AURORA ENERGY LIMITED

AURORA ENERGY'S SUBMISSION IN RESPONSE TO THE COMMISSION'S DPP3 DRAFT DECISION

Commerce Commission: Default price-quality paths for electricity distribution businesses from 1 April 2020 – Draft decision

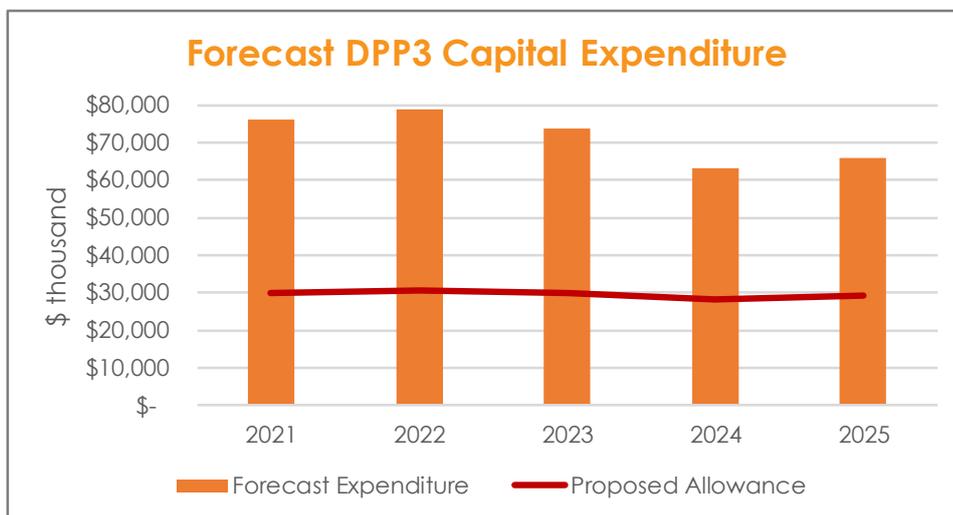
7 The use of an historic reference period is premised on the proposition that the most informative guide to future capex requirements is past capex requirements. However, the approach does not adequately capture cyclical changes in capital investment requirements. Specifically, in Aurora's case the use of a seven-year reference period significantly understates Aurora's future capex requirements. This is because of Aurora's low level of historic investment, which has resulted in deterioration of network assets that now requires remediation (as set out in detail in our 2018 AMP and 2019 AMP update). The step change in Aurora's capex as we address this historic under-investment is illustrated below.

8 The early years of the proposed historic reference period capture a number of years in which Aurora was under-investing. These years are therefore not an informative guide to Aurora's future capex requirements. Based on Aurora's AMP, capping Aurora's expenditure based on a seven-year period would result in a capex shortfall of ~\$46 million in year one of DPP3.

- 11 This information supports a shorter historic reference period that places more weight on Aurora's recent increase in capex. Relying on the information that the Commission has at hand, to set a shorter reference period, is consistent with the DPP's low-cost objective and better achieves the Part 4 purpose statement because it will allow Aurora to invest appropriately in the long-term interests of its consumers.
